API Ballot 6579

| Title of Work Item | Update Lift Sub Sizes and Dimensions |
| API Document Modified | 7-1 2e |

Work Item Charge: add new size to Lift Sub section, and update marking

Figure 6—Lift Subs (Type D)

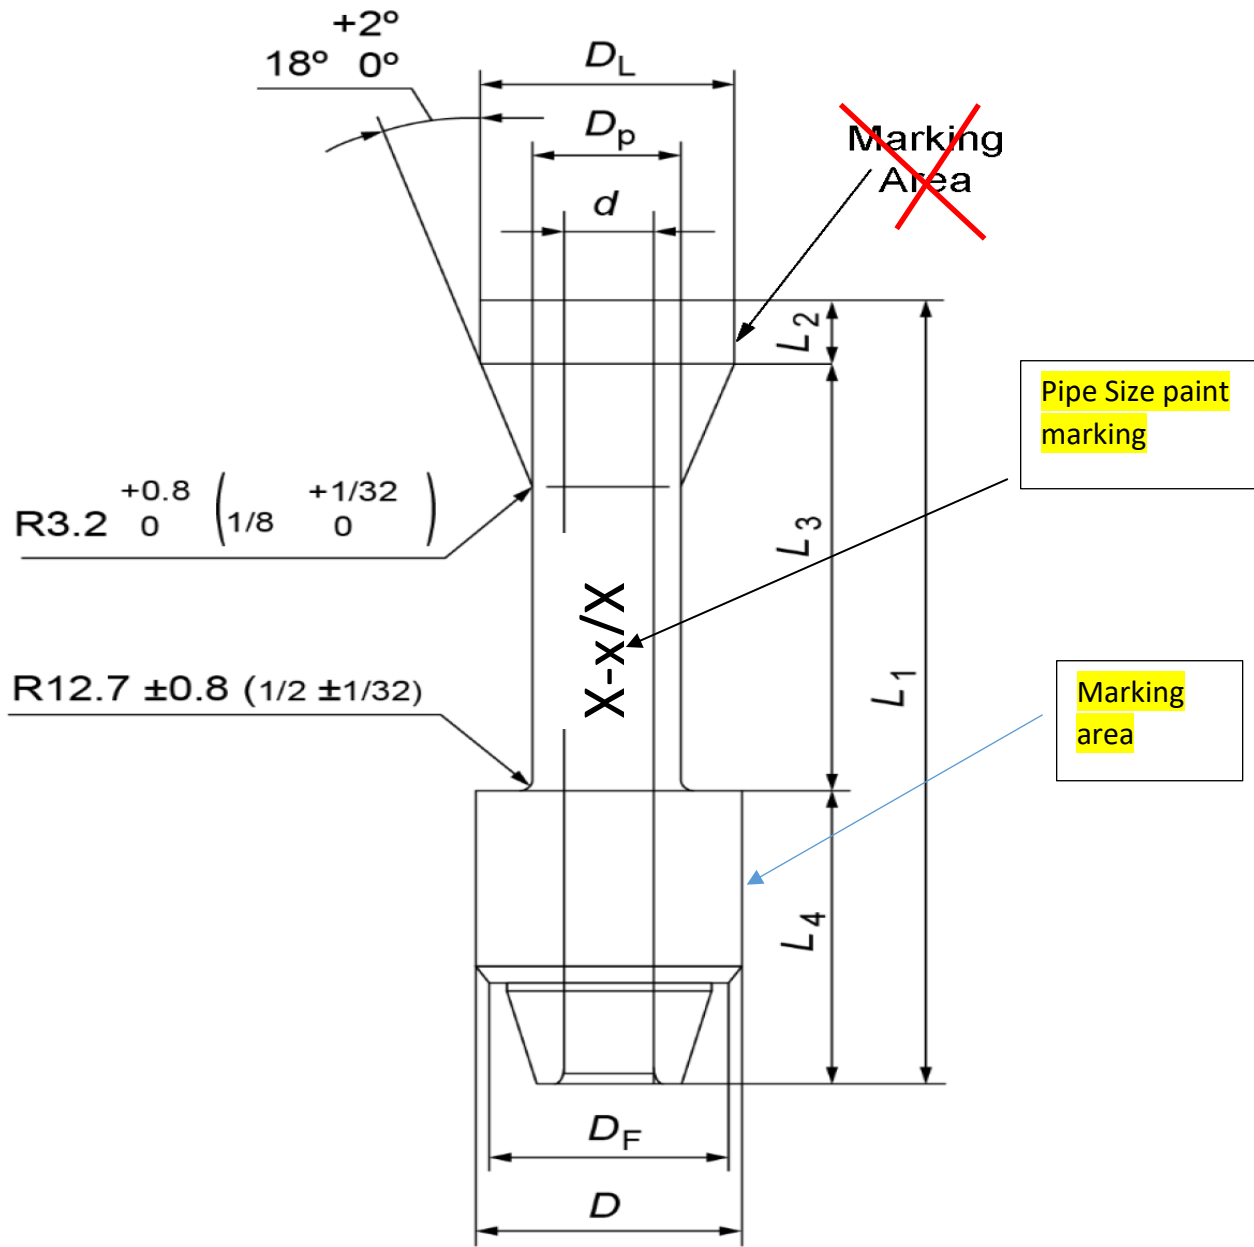
Lengths and tolerances for Type D drill stem subs shall conform as applicable to Table C.12 (Table D.12), shall be as shown in Figure 6.
